ALERT SERVICE BULLETIN

407-24-136

MODEL AFFECTED: 407

SUBJECT: STANDARD AND HIGH LANDING GEAR FORWARD CROSSTUBES – INSPECTION OF

Figure 1- Forward Crosstube Inspection Area

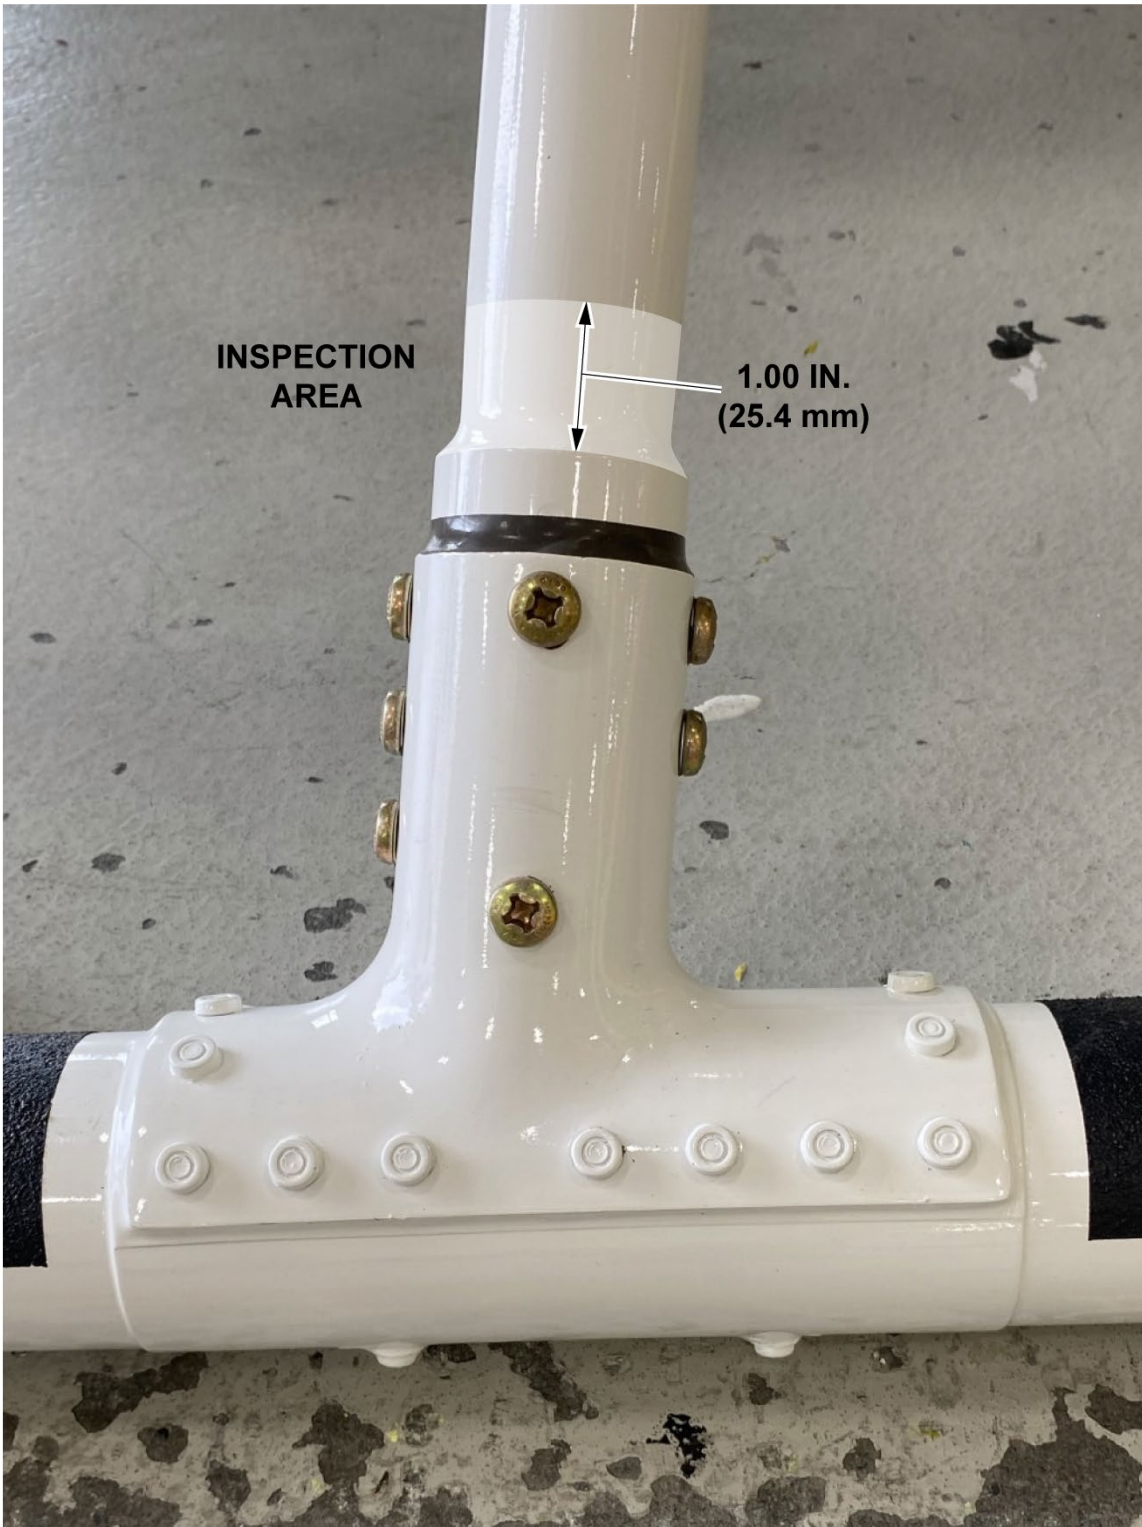
The inspection area is one inch in length just above the skid tube saddles and around the complete circumference of the crosstube (Figure 1).

3. Clean the areas to be inspected on the lower end of the left and right side of the crosstube using cleaning compound (C-318) (Figure 1).
4. Apply tape (C-439) around the areas to be stripped of paint and primer.

6. Perform a Fluorescent Penetrant Inspection (FPI) in the stripped area around the complete circumference of the crosstube (BHT-ALL-SPM, Chapter 6)
7. Remove tape and clean the inspected areas following the FPI (BHT-ALL-SPM, Chapter 6).

1. Prepare the helicopter for maintenance.
2. Clean the areas to be inspected on lower end of the left and right side of the crosstube using cleaning compound (C-318) (Figure 1).

3. Perform a detailed visual inspection of the affected areas using a 10X magnifying glass around the complete circumference of the crosstube.
4. If no crack is detected proceed to step 7.

8. If no crack is detected, apply primer (C-204) to the stripped area and two light coats of white polyurethane paint FED-STD-595, color code 17925, (C-245) (BHT-ALL-SPM, Chapter 4). Proceed to step 11.
9. If a crack is detected during the FPI, remove the standard low gear crosstube ([DMC-407-A-32-01-02-00A-520A-A](#)) or high gear crosstube from service ([DMC-407-A-32-02-02-00A-520A-A](#)), as applicable. If a crack is detected, report the findings to Product Support Engineering at productsupport@bellflight.com.
10. Install a serviceable standard low gear crosstube ([DMC-407-A-32-01-02-00A-720A-A](#)) or high gear crosstube ([DMC-407-A-32-02-02-00A-720A-A](#)), as applicable.

5. If a crack is detected during the 10X inspection, remove the standard low gear crosstube ([DMC-407-A-32-01-02-00A-520A-A](#)) or high gear crosstube ([DMC-407-A-32-02-02-00A-520A-A](#)), as applicable. If a crack is suspected during the 10X inspection but cannot be confirmed, perform FPI per **PART II** steps 4 through 9. If a crack is detected report the findings to Product Support Engineering at productsupport@bellflight.com.
